AURORA HIGHLINE FILING No. 3 SITE PLAN AMENDMENT WITH WAIVER AND CONDITIONAL USE

DRAWING: COVER SHEET

AURORA HIGHLINE FILING No. 3 SITE PLAN AMENDMENT No. 2

PROJECT: **AURORA HIGHLINE FILING No. 3**
DRAWING: **OVERALL EXISTING SURVEY & DEMO PLAN**
CLIENT: **MIKE NAUGHTON**

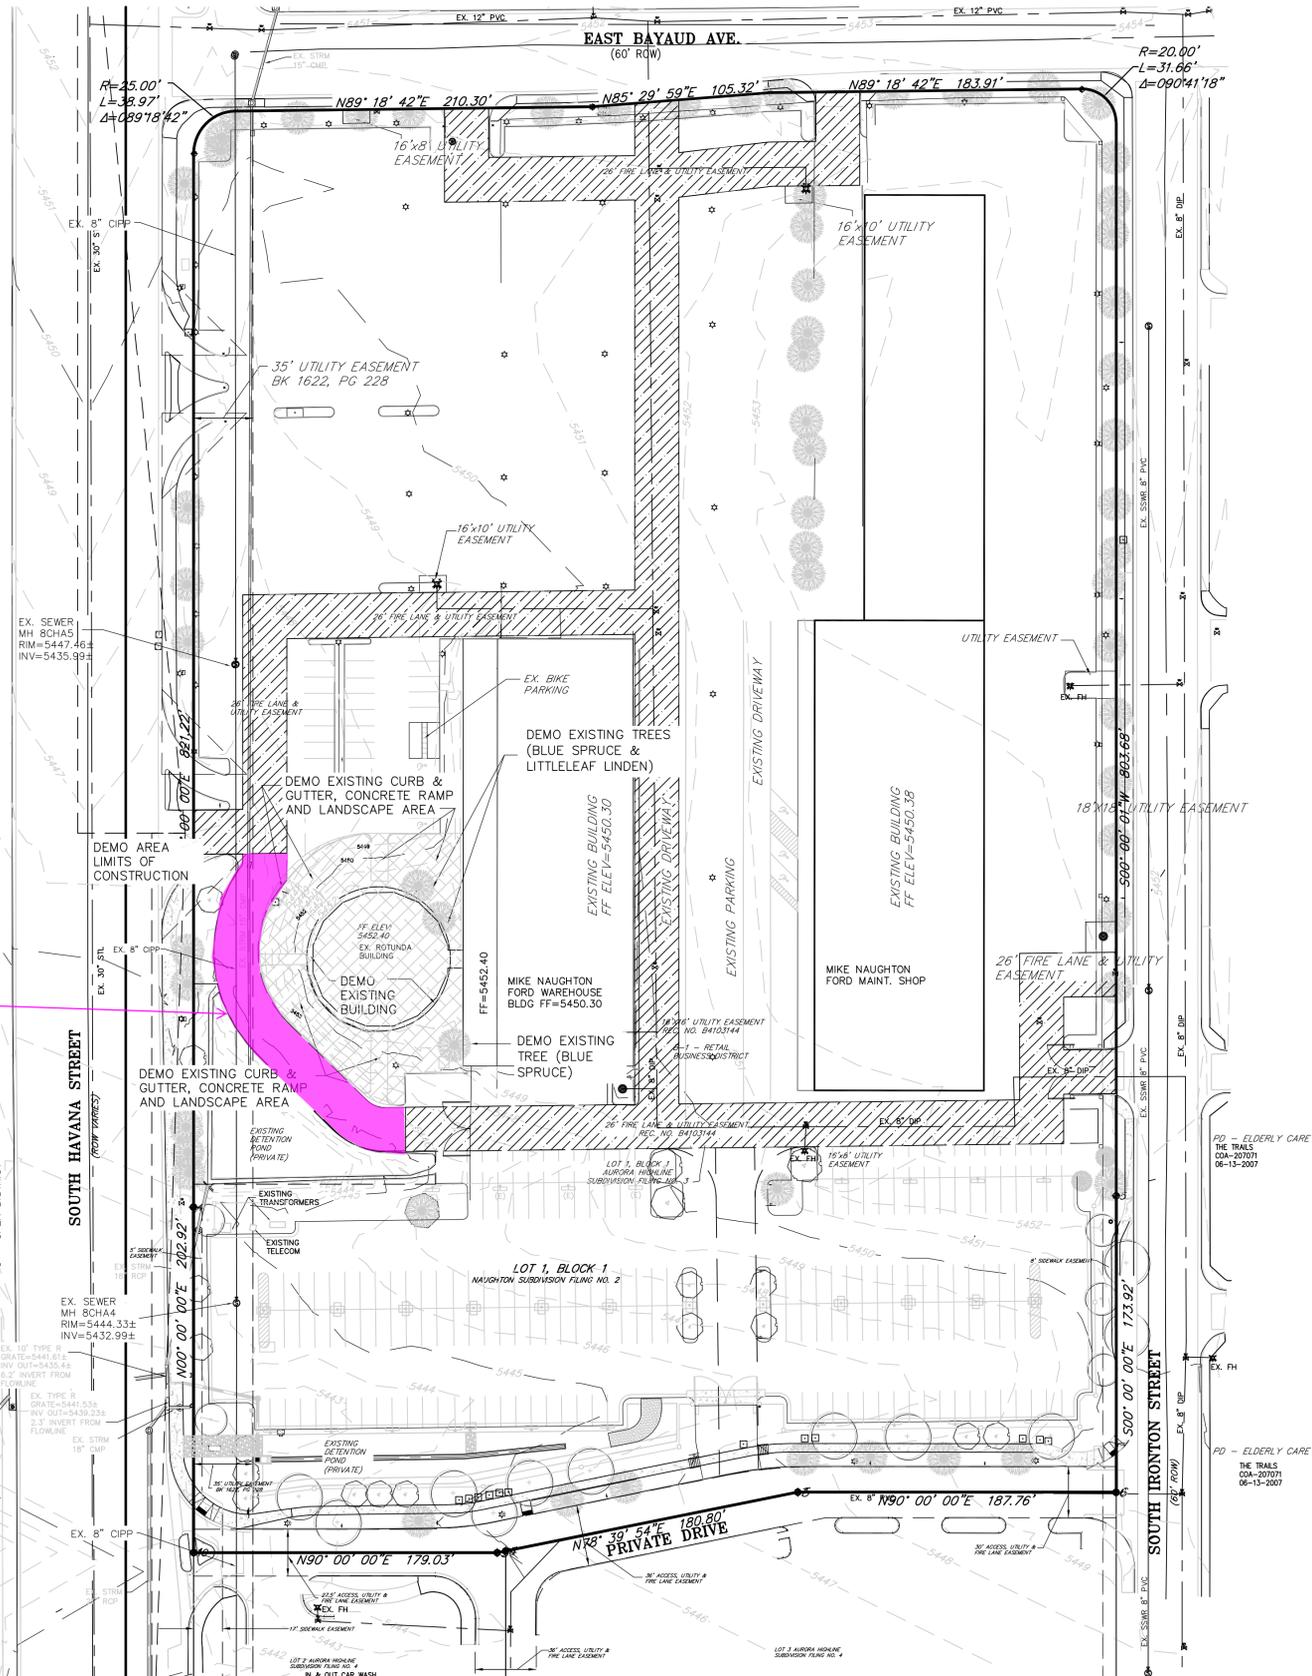
Please distinguish as to what portion of fire lane shall be released so that this is clear and easily determined.

SOUTH ELEVATION
1/8" = 1'-0"

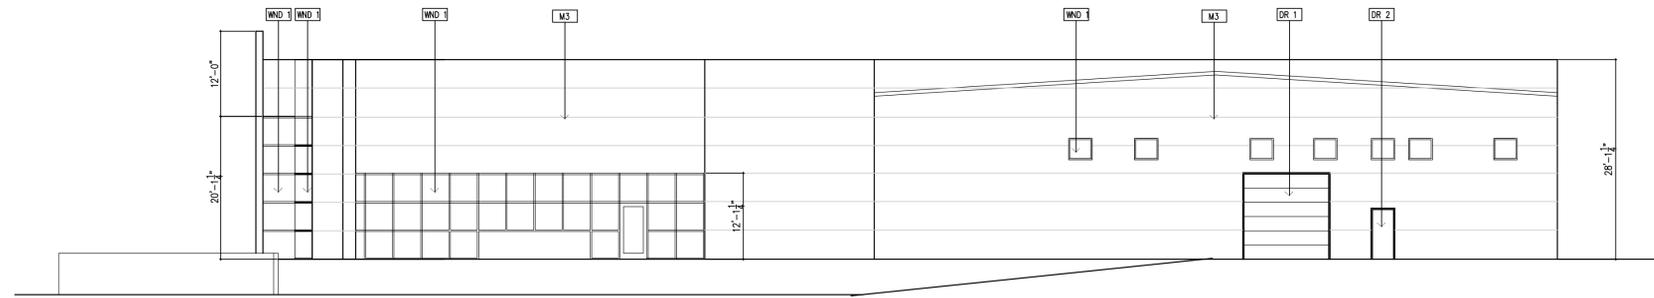
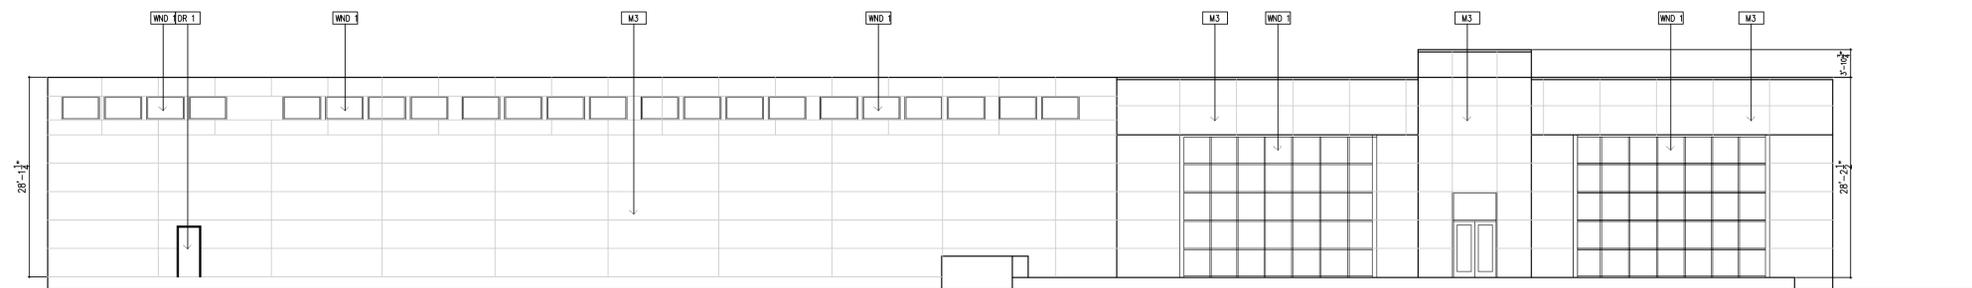
Please check the elevations to ensure proper labeling. I do not see 'WND 2' used on any of the elevations.

NORTH ELEVATION
1/8" = 1'-0"

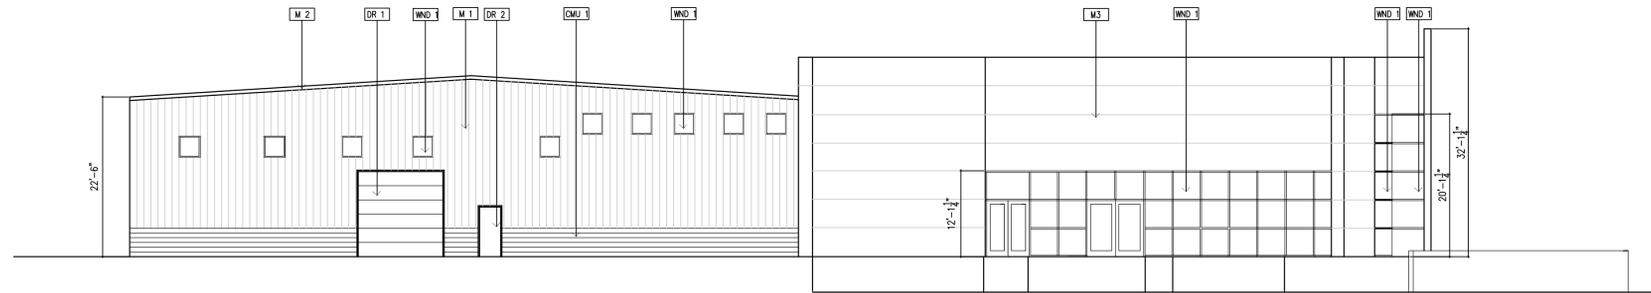
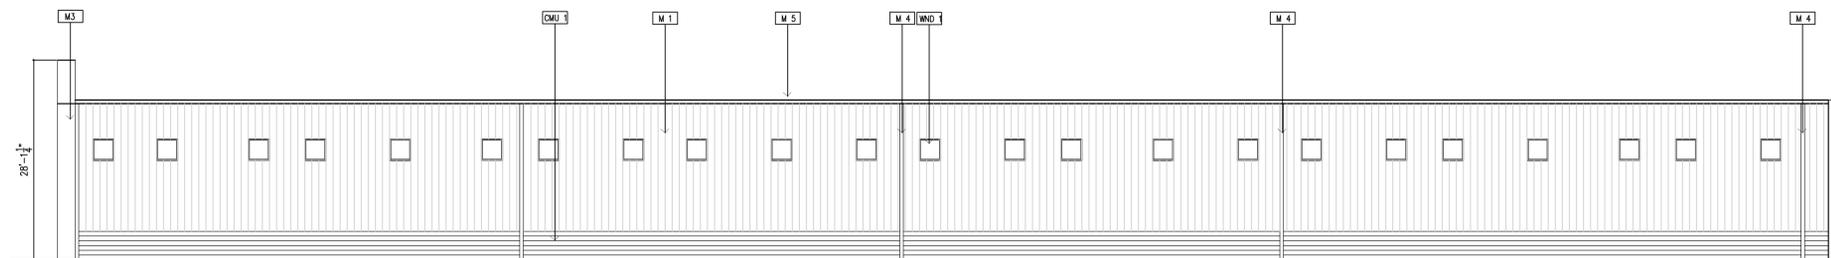
Please check the elevations to ensure proper labeling. I do not see 'WND 2' used on any of the elevations.
